Addendum No. 2

Number: RFT 2026-011

Project: Town of Watson Lake – Wye Lake Trail and Sign Post Forest Trail Improvements

Drawing Title:
RIP RAP SLOPE PROTECTION - SECTION

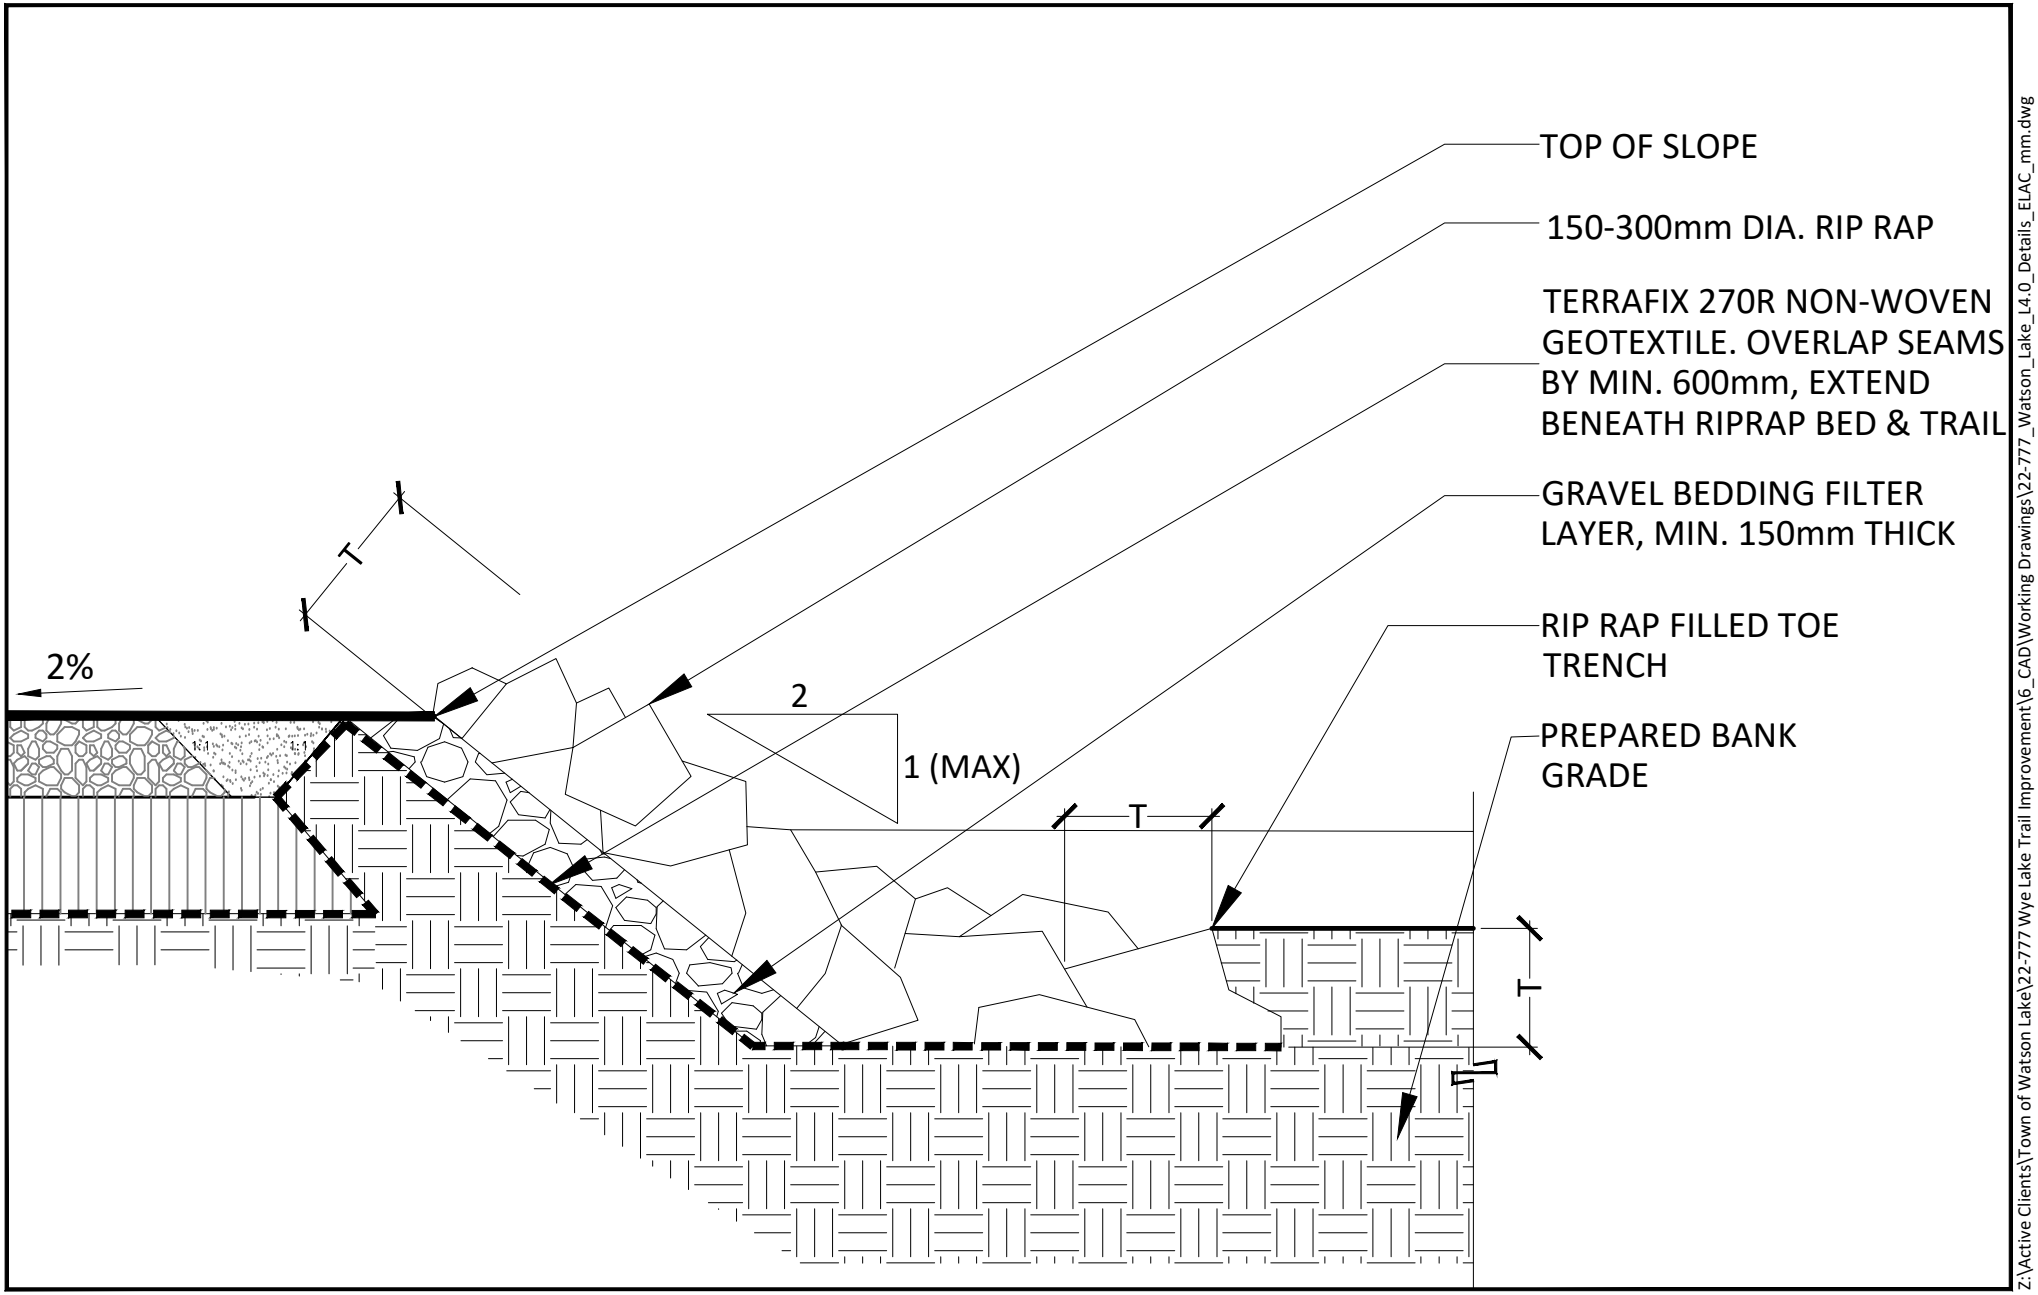
a. Question: Rip Rap: Bid sheet shows Rip Rap in volume (100m3). The plans show possible rip rap being required over 430 linear meters and detail 4/L4.3 shows a section which will likely involve over 2m of bank placement. Should rip rap be required over 430 linear meters then the volume would be substantially higher than 100m3.

a. Question: Rip Rap: The bid sheet states volume (100m3) however the detail 4/L4.3 required geo fabric and aggregate placed on an area basis (m2) in order to determine quantities and labour/equipment time. Secondly does the geo fabric from bid sheet line 3.1 include areas under rip rap, or this additional and part of the line 3.4 Rip Rap payment item?

a. Question: Rip Rap Areas: Detail 4/L4.3 shows continuous fabric, aggregate and rip rap from top of bank to bottom of bank. The area on the southern lake that slopes into the lake contains bush, trees and mud that runs right down/near the water line. Detail 4/L4.3 does not show the waterline. Is the intent to have the rip rap down to the water level, understanding the environmental considerations/precautions that will be required?

b. Response: See revised Detail 4/L4.3 and 00 41 43 Bid Form attached. The required Rip Rap is increased to 300 m3.

b. Response: Geotextile fabric quantity on bid sheet line 3.1 for the Wye Lake Trail has been updated to include required geotextile for Rip Rap placement. See revised 00 41 43 Bid Form.

b. Response: Sections of the 430 linear metre length of trail along the south shore will require Rip Rap placement into the water level to accommodate the required trail width. A YESAB assessment has been completed for this work, and Water License Requirements will be handled by the Town of Watson Lake. A fish habitat assessment was completed in 2025, recommending Wye Lake is considered not fish-bearing. Refer to YESAA Document in Appendix E for additional information on mitigations during construction activities.
